Southern Nuclear Operating Company
Vogtle Early Site Permit Application
Safety Review Site Audit Hydrology Information Needs

Enclosure: Responses to NRC Site Hydrology Information Needs From January 2007 Safety Review Site Audit For the Vogtle ESP Application

Information Needs from the January 2007 Safety Review Site Audit

Item #1 Figure 1

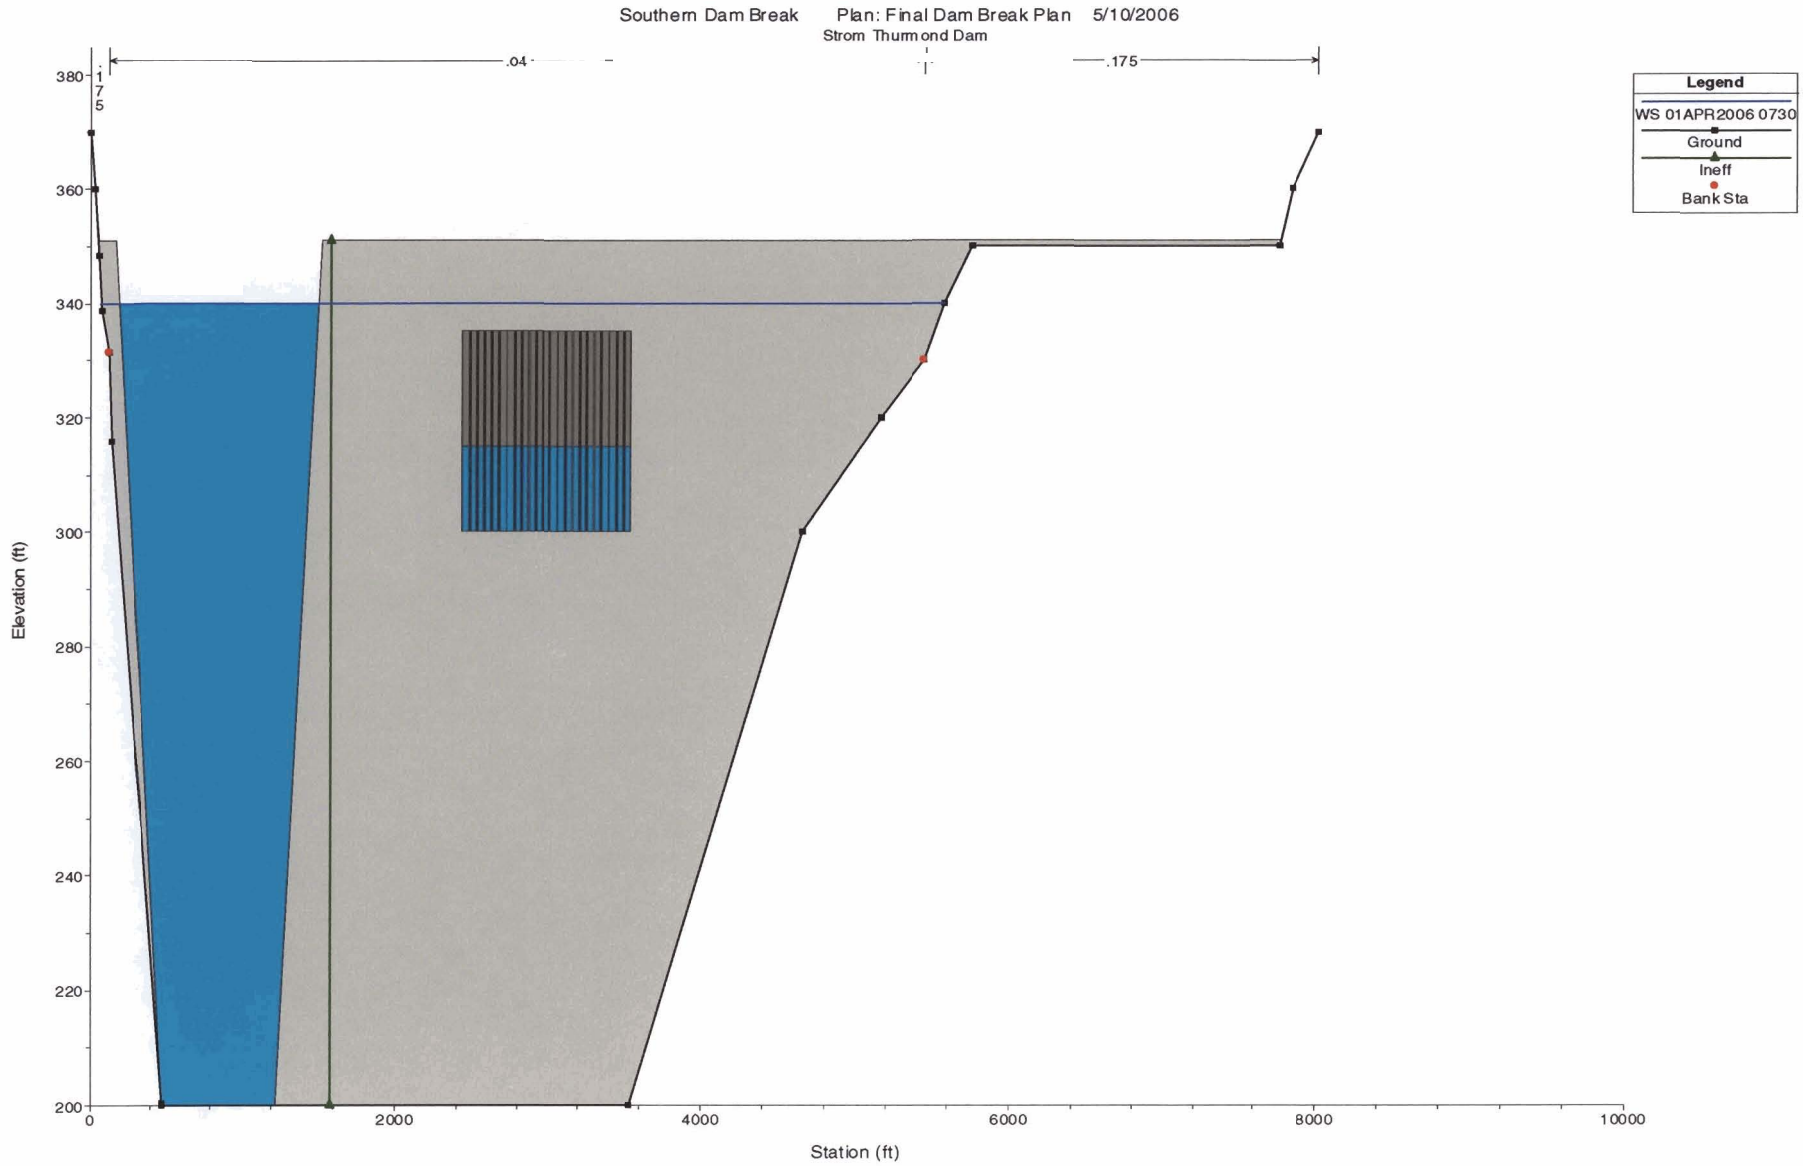
Item #1 Present the calculations used to estimate the dam breach parameters discussed on page 2.4.4-4 and outlined in the USBR.

2) As shown on Item #1 Figure 1 of this response, the total dam width at the top of the dam is about 5,700 ft. (Reference 2). The width of the dam at the upstream invert elevation (El. 200 ft) is about 2,840 ft. Located within the portion of the dam that extends to El.. 200 ft is a concrete embankment section 2,282 ft wide where the tainter gate spillways and powerhouse are located (Reference 2). The failure mode assumes that only the earth section of the dam will erode during the breach. Consequently, the 755-foot bottom width of the breach extends beyond the area in which the actual ground elevation is at the minimum ground elevation of El. 200 ft.

3) Superposing the 755-foot bottom width at El 200 ft on the cross-section of the valley on the upstream side of the dam shows that more than 200 feet of the breach would be above El. 200 ft. Therefore, the entire bottom of the breach was taken as El. 200 ft to be conservative. The cross section shown in Figure 1 has been artificially widened at El. 200 ft to accommodate the 755 ft wide breach.

Based on a review of data and analyses for 84 dam failure cases, and the physical layout of J Strom Thurmond Dam, a breach width of 755 ft, with 2 to 1 side slopes was selected for this analysis. Additionally, most of the breach time predictions are close to 1.0 hour. Thus, a breach time of 1.0 hour was selected for this analysis.
